Harbourfront Centre Water's Edge Revitalization Project Value Engineering Study

Presented by: Andrew Hachborn, M.Sc., P.Eng., AVS
Marshall Macklin Monaghan Limited

VE Study was carried out by the
Toronto Waterfront Joint Venture for
the Toronto Waterfront Revitalization
Corporation

Finger Piers – Base Case

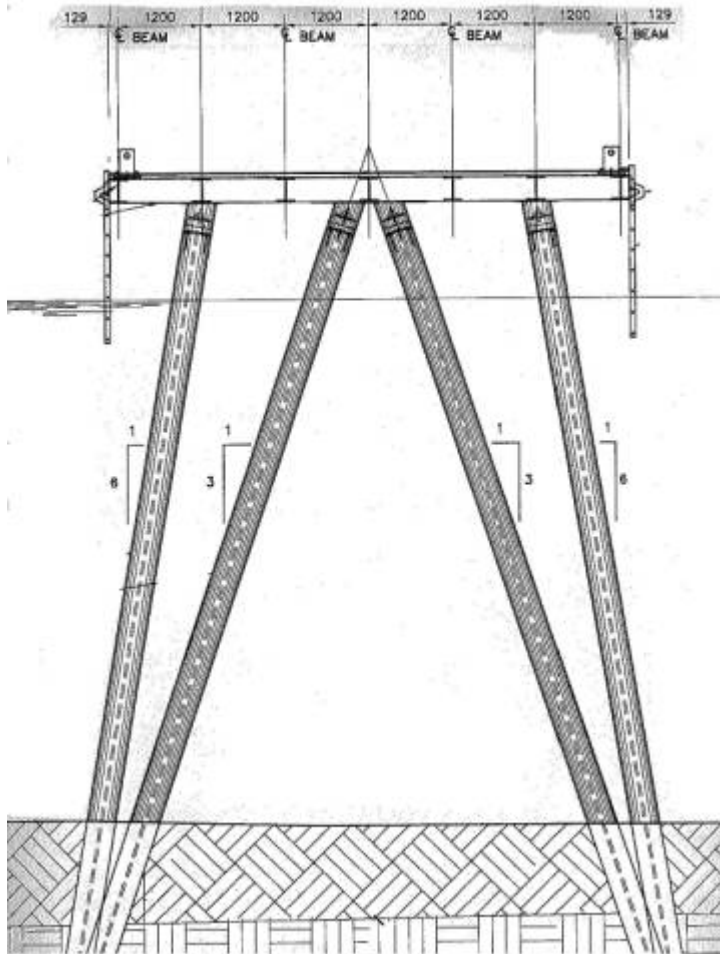
- Piles driven open-ended, cut to exact height, material removed from interior of piles
- Tension anchor installed into bedrock through end of pile, grouted and pile filled with concrete
- Steel framework welded to bents constructed of 3 or 4 tension/compression piles
- Wood deck fastened to structural steel framework

Finger Piers - Alternatives

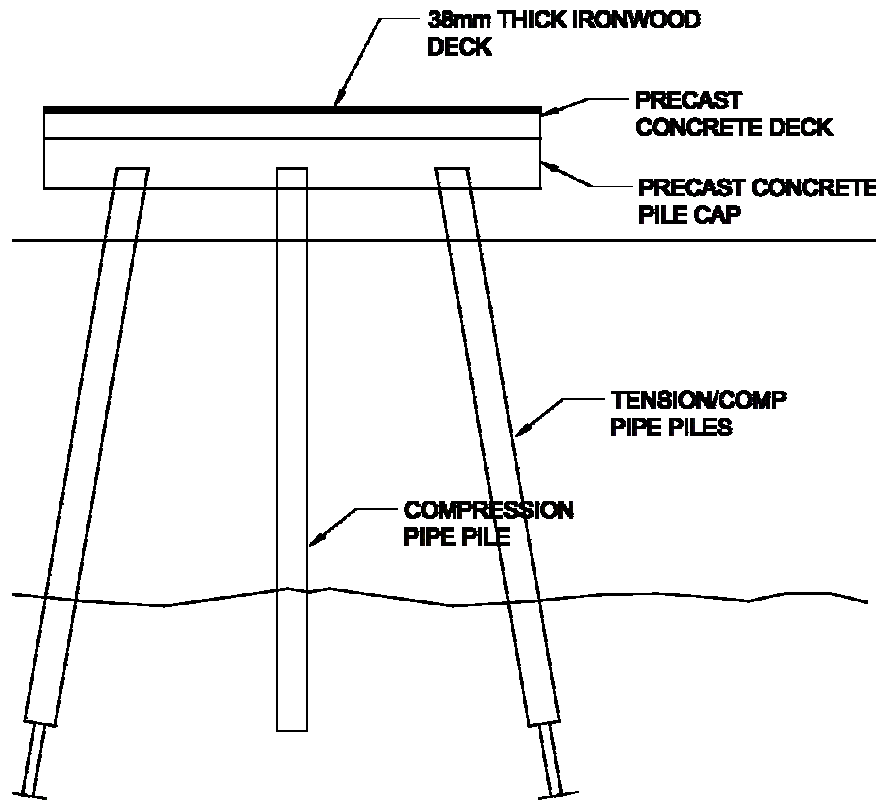
- Floating Finger Piers with Precast and Steel Tube Floats \$ 380,000
- Precast Concrete Deck Structure on Reduced Pile Arrangement \$ 584,000
- Steel Deck Structure on Reduced Pile Arrangement \$ 338,000

Selected Finger Piers Alternative

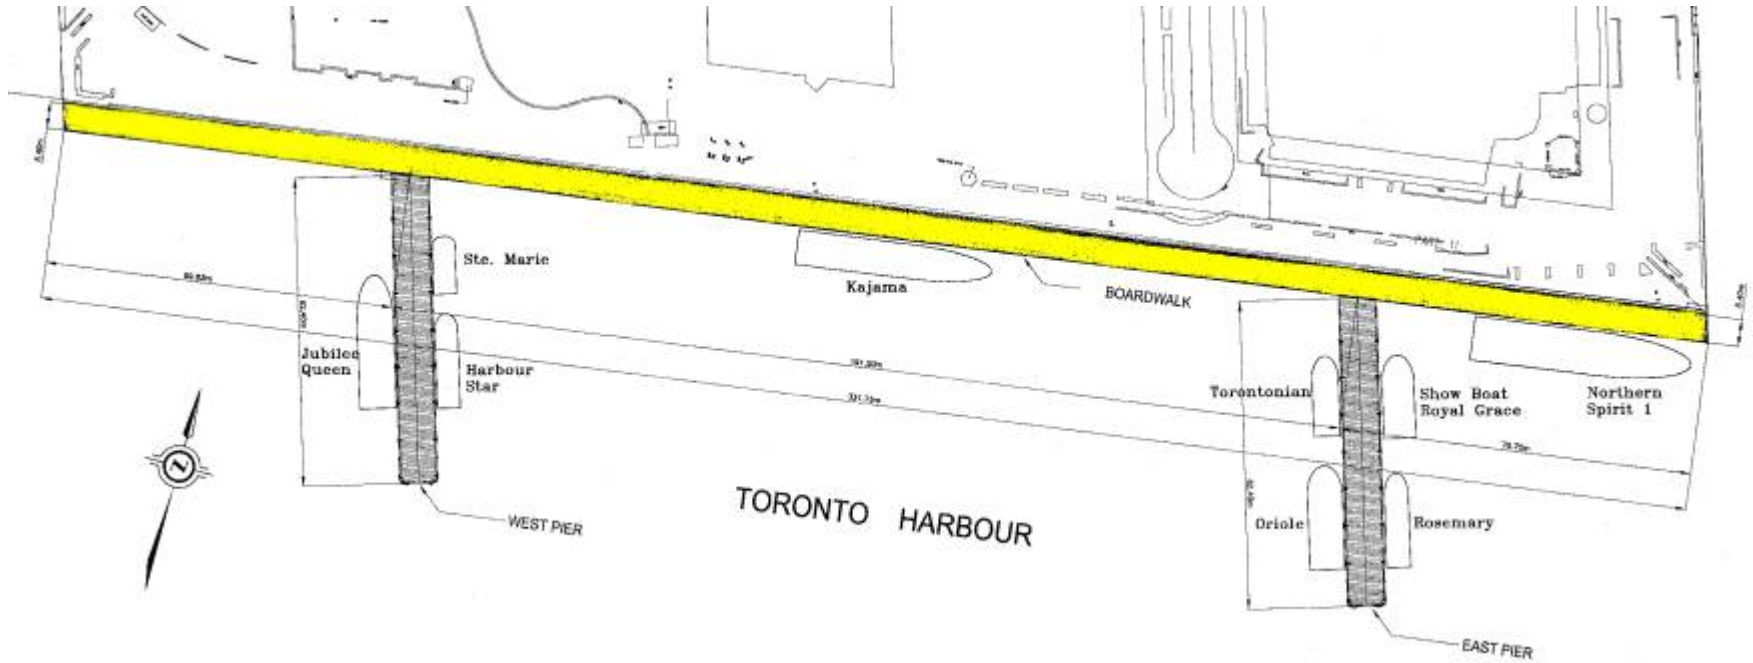
- Piles driven closed-ended
- 2 tension/compression pipe piles and one compression pile per bent
- Tension anchor installed into bedrock through end of pile, grouted and pile filled with concrete
- Wood deck fastened to non-bio-degradable nailing strips, embedded in precast concrete deck structure

Boardwalk – Base Case

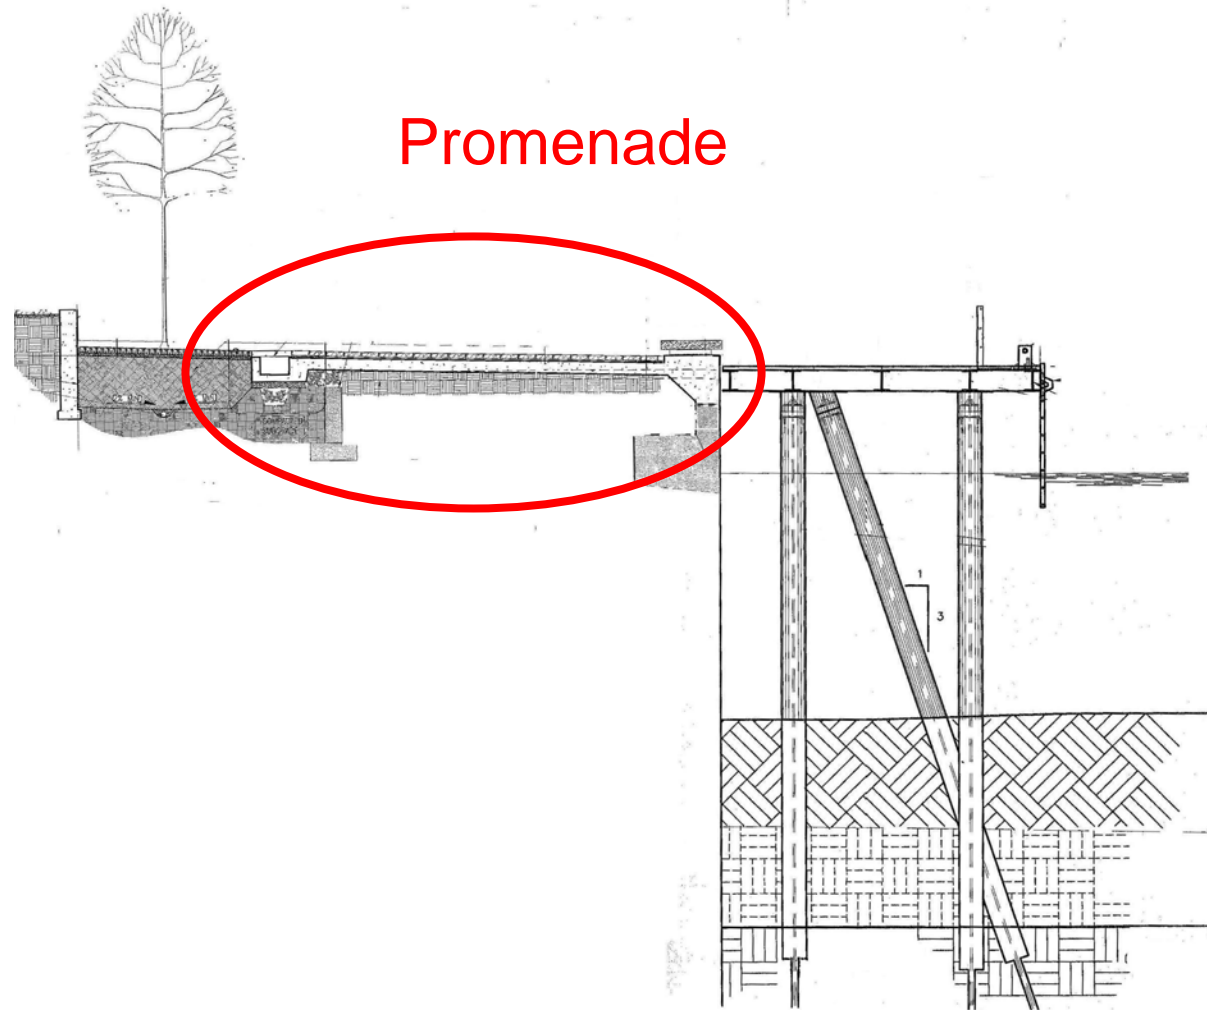
- Constructed on grade with lakeshore edge supported on existing crib wall
- Designed to bridge over any localized loss of material/ support due to failure of crib wall

Boardwalk – Base Case

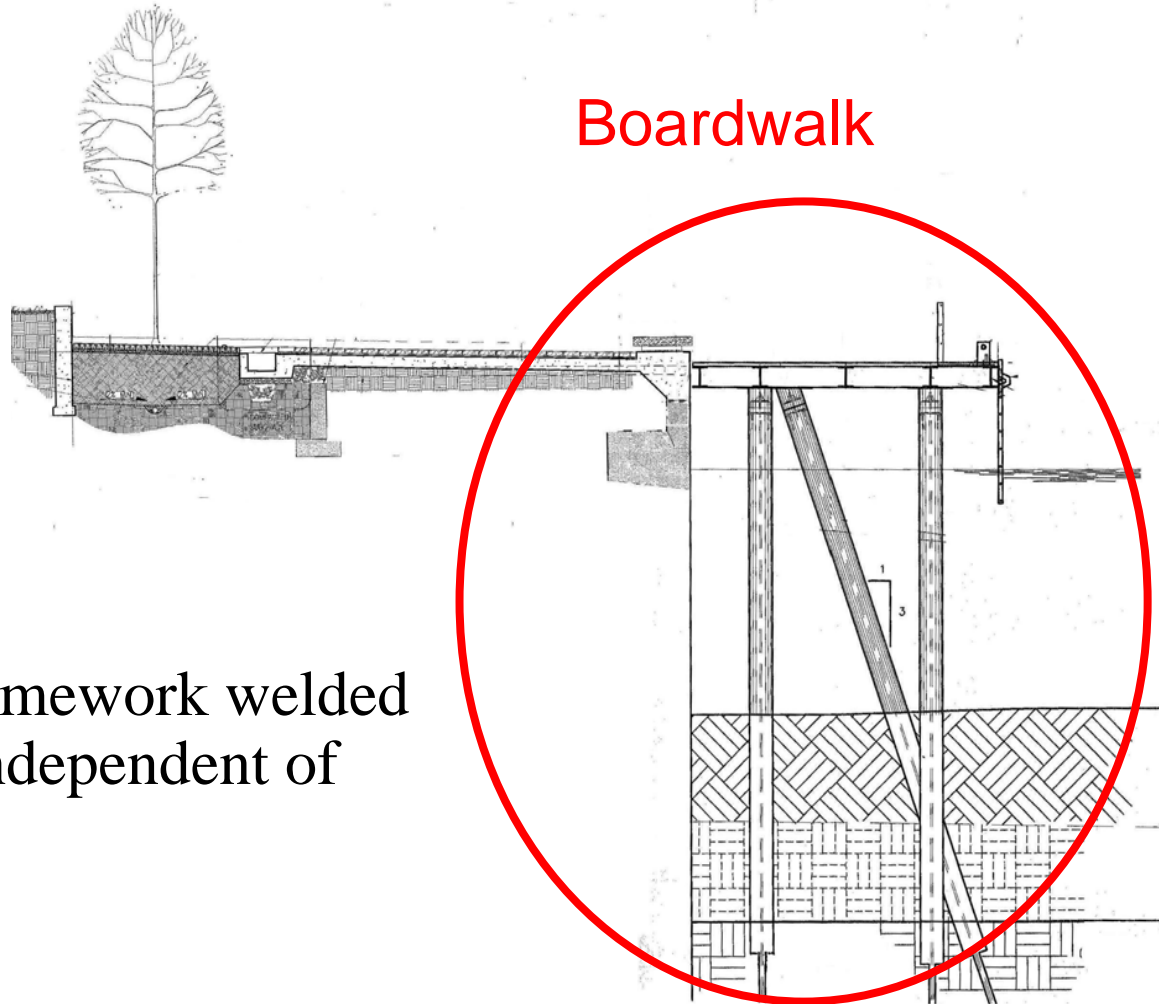
- 3 tension/compression piles driven open-ended and cut to exact height, material removed, tension anchor installed into bedrock, grouted and filled with concrete
- Structural steel framework welded directly to piles, independent of existing wall
- Wood deck

- Any movement of the front part of the crib wall impacts the structural integrity of the promenade slab resulting in movement or rotation of the complete slab.
- During repair of crib wall heavy equipment will not be able to work supported on the promenade slab.
- New 50 year lifespan structure will be supported on structure with 20 year remaining life (some movement will most likely occur prior to 20 years)

Selected Boardwalk Alternative

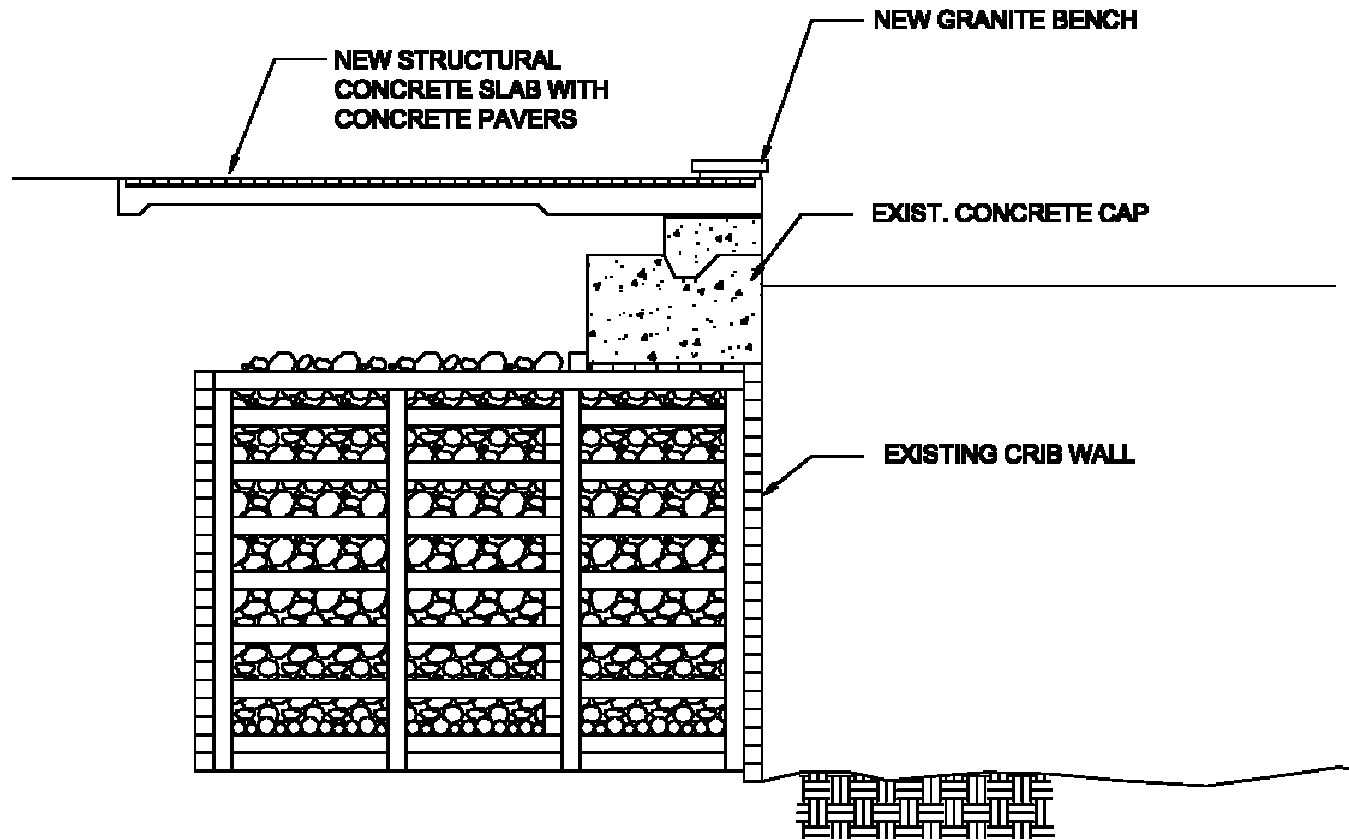
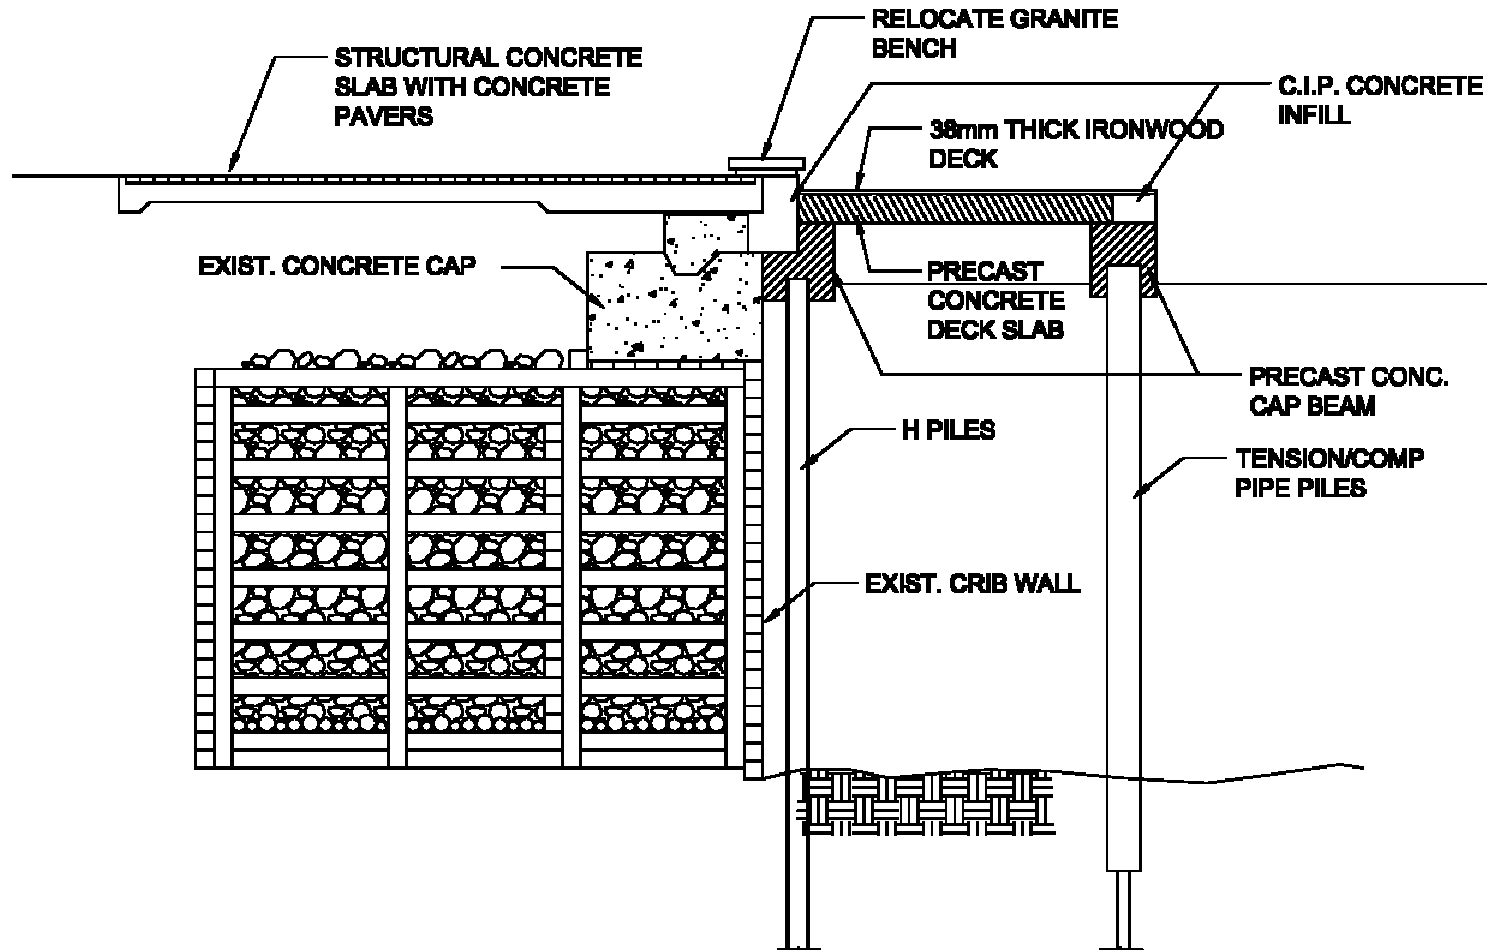
ORIGINAL CONFIGURATION

PROPOSED PROMENADE CONFIGURATION

- Use Precast Concrete Deck Structure
- Reduce Pile Arrangement
- Reduce Thickness of Wood Deck
- Thicken Promenade Slab and Span to H-Piles
